MODIFICATION SHEET FOR PROVISION OF INDICATIONS ON-BOARD OF
4.5kW UNDERSLUNG CONSTANT VOLTAGE REGULATED CUM EMERGENCY
BATTERY CHARGER IN THE SWITCH BOARD CABINET OF LHB TYPE
EOG/HOG AC AND IN LV PANEL FOR LHB TYPE EOG/HOG NON-AC
COACHES TO MONITOR BATTERY AND BATTERY CHARGER STATUS

MODIFICATION SHEET NO. RDSO/PE/MS/AC/0095-2024 (Rev 0)

RESEARCH DESIGNS AND STANDARDS ORGANISATION
MANAK NAGAR, LUCKNOW-226011
Modification sheet no RDSO/PE/MS/AC/0095-2024(Rev-0)

New Variant of Switch Board Cabinet

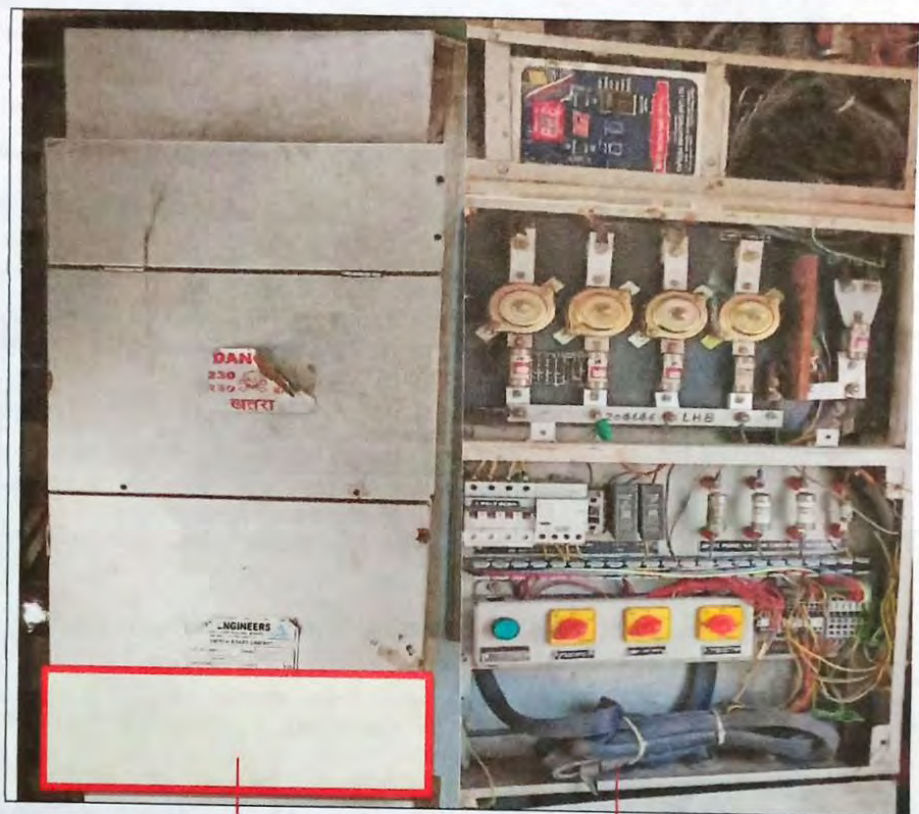
- a) The Switch Board Cabinets as per RDSO specification no. RDSO/PE/SPEC/AC/0184-2015 (Rev.1), RDSO/SPEC/AC/0192-2018 (Rev.1) and RDSO/PE/SPEC/AC/0200-2020 (Rev.0) are already provided with S1H03 and S1H06 PCB based indication LED/ indication pilot lamp for RBC OK and Battery not healthy respectively. The spare S1H15 indication lamp (Red) to be used for battery not healthy and connection of this Indication lamp S1H15 is to be arranged as per sheet no. 24 of 48 of RDSO drawing no. RDSO/PE/SK/AC/0206-2019(Rev.0) enclosed as Annexure B.

- b) Existing Indication S1H06 for Battery not healthy is now to be rewrite as EBC ON.

- c) For the wires coming from 4.5 kW RBC cum EBC, if wires are not present then, wires are to be laid as per the harness details furnished below

- d) If not done already, the connections in the UREBC to be made through auxiliary interlocks from the incoming supply contactor/relay present in the RBC cum EBC i.e. NO for RBC OK and NC EBC ON.
- e) Connection for Battery not healthy to be provided through additional card provided in REBC unit as per RDSO drawing no RDSO/PE/SK/AC/0254-2024 (Rev-0) enclosed as Annexure C. This is a general schematic diagram in Annexure C. The Modification to be done on card level to meet the general schematic and should acknowledge the desirable indication on-board.

7.0 DRAWING/ REFERENCE:
Attached Annexures.

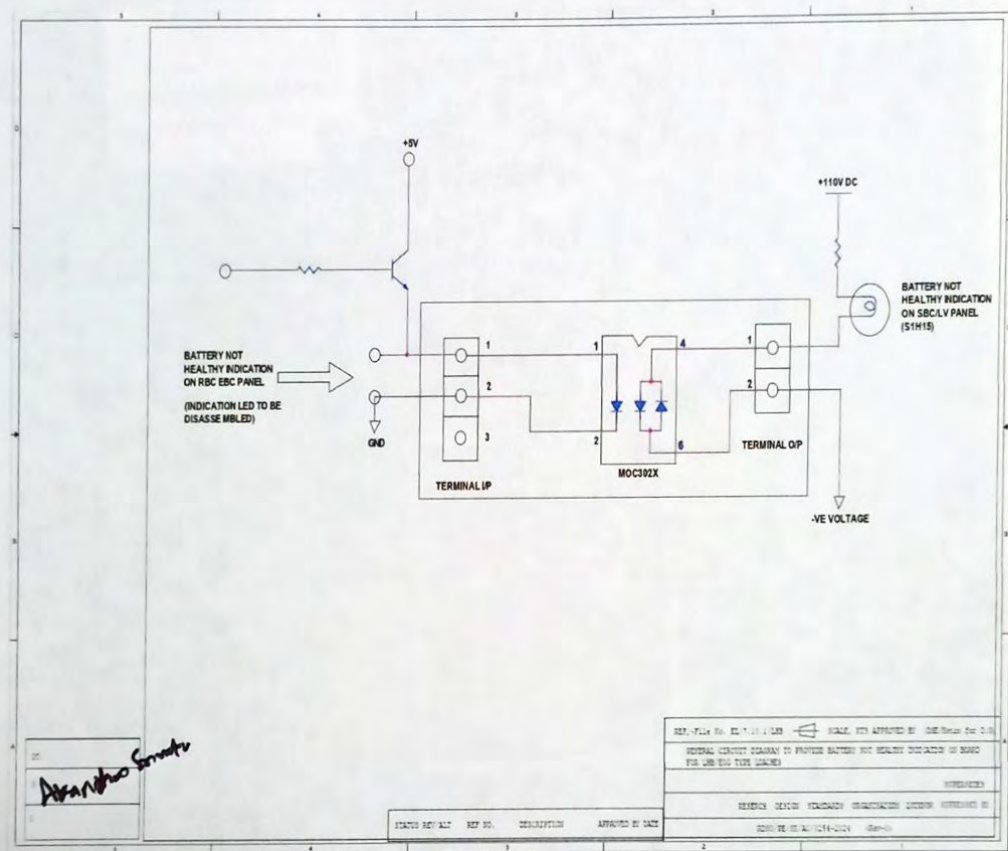
- b) The connections of indications are to be arranged as per sheet no. 23 of 48 of RDSO drawing no. RDSO/PE/SK/AC/0206-2019 (Rev.0) enclosed as Annexure A with S1H03 and S1H06 for RBC OK and EBC ON respectively and for Indication S1H15 is to be arranged as per sheet no. 24 of 48 of RDSO drawing no. RDSO/PE/SK/AC/0206-2019 (Rev.0) enclosed as Annexure B.

ANNEXURE C

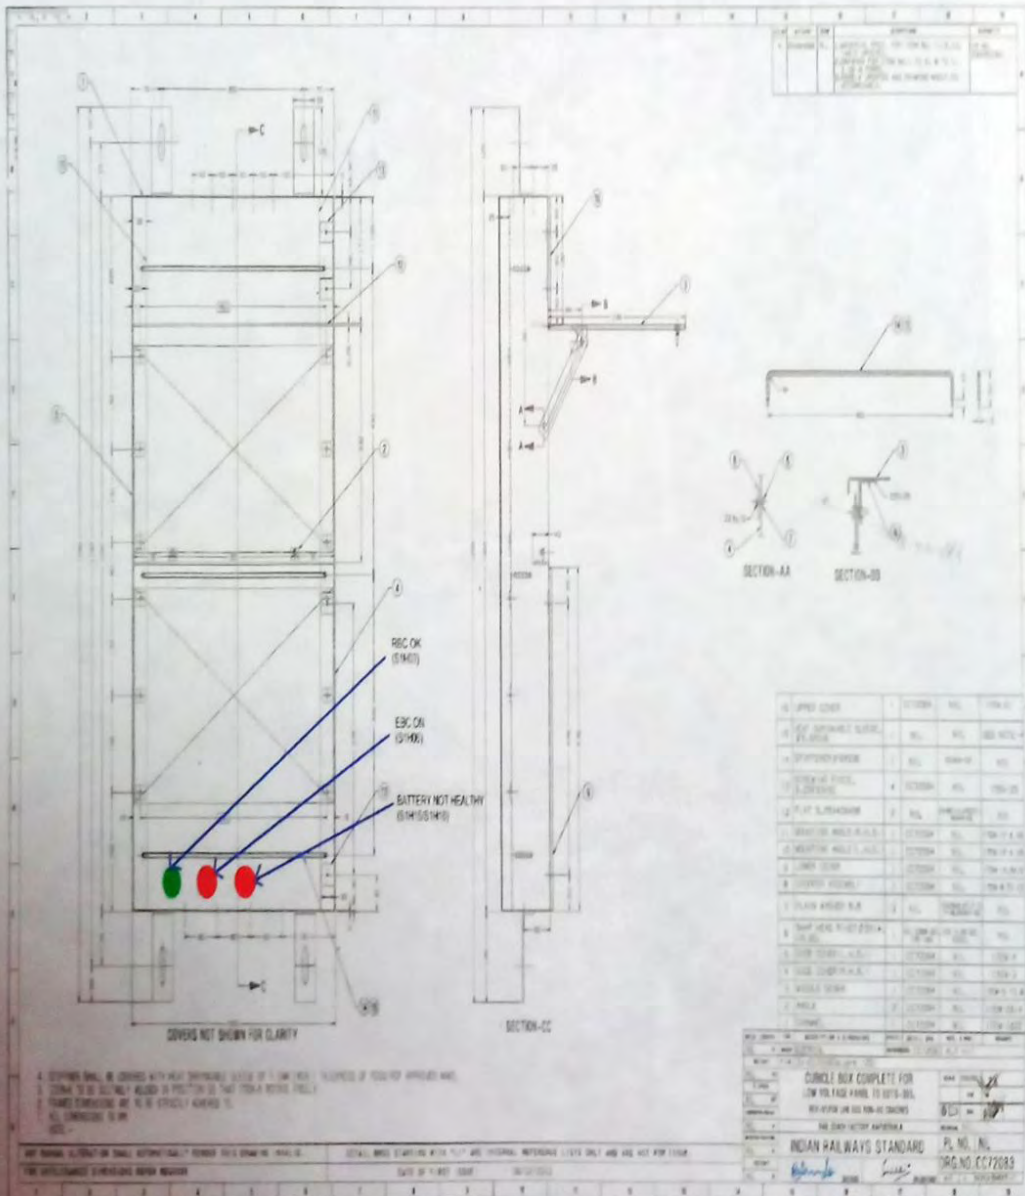
- d) Connection for Battery not healthy to be provided through additional card provided in REBC unit as per RDSO drawing no RDSO/PE/SK/AC/0254-2024 (Rev-0) enclosed as Annexure C. This is a general schematic diagram in Annexure C. The Modification is to be done on card level to meet the general schematic and should acknowledge the desirable indication on-board.
